Access Compliance Report

Public Rights-of-Way

(Curb Ramps)

Intersection ID: 44008	Main Street: ARCOLA_LN	Cross Street: DEMAINE_DR	Location: S
ADA ID: 94CACE2D6E14	Ramp Type: PerpDiag	Initial Pass/Fail: Fail	Overall Compliance: No
Severity Score: 31.25			
Codes/Mitigation Info/Possible Solution		Field Measurements/Component Compliance

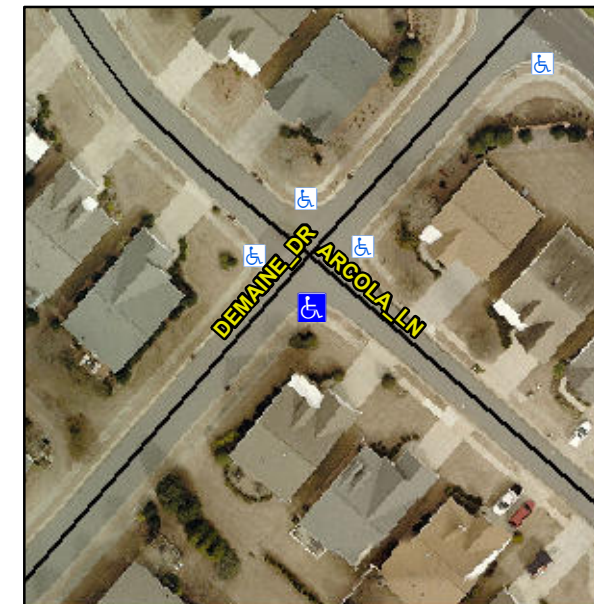
Not Found, R304.5.1, R304.2.2, R304.5.3

Compliance	Description	Data	Compliance	Description	Data
N/A	Ramp Length (in)	44.0	No	Ramp Slope (%)	10.1
No	Ramp Width (in)	34.0	No	Ramp XSlope (%)	2.6
N/A	Flare Type LT	N/A	N/A	Flare Type RT	N/A
N/A	Flare Slope LT (%)	N/A	N/A	Flare Slope RT (%)	N/A
N/A	Flare Traversable LT?	N/A	N/A	Flare Traversable RT?	N/A
N/A	Landing Length (in)	N/A	N/A	DWS Provided?	N/A
N/A	Landing Width (in)	N/A	N/A	DWS Contrast?	N/A
N/A	Landing Slope (%)	N/A	N/A	DWS Length (in)	N/A
N/A	Landing X Slope (%)	N/A	N/A	DWS Full Width?	N/A
N/A	Landing Curb? (Y/N)	N/A	N/A	DWS Offset (in)	N/A
N/A	Shared Landing?	N/A			
N/A	Gutter Ponding?	N/A	N/A	Gutter Slope (%)	N/A
N/A	Gutter Lip Ht (in)	N/A	N/A	Gutter X Slope (%)	N/A
N/A	Painted X Walk1?	No	N/A	Painted X Walk2?	No
	X Walk 1 Direction	To NE		X Walk 2 Direction	To NW
N/A	X Walk 1 Width (in)	N/A	N/A	X Walk 2 Width (in)	N/A
	X Walk 1 Slope (%)	2.8		X Walk 2 Slope (%)	3.2
	X Walk 1 X Slope (%)	2.6		X Walk 2 X Slope (%)	1.9

Remove & Replace Curb Ramp With Two New Directional Ramps or Equivalent.
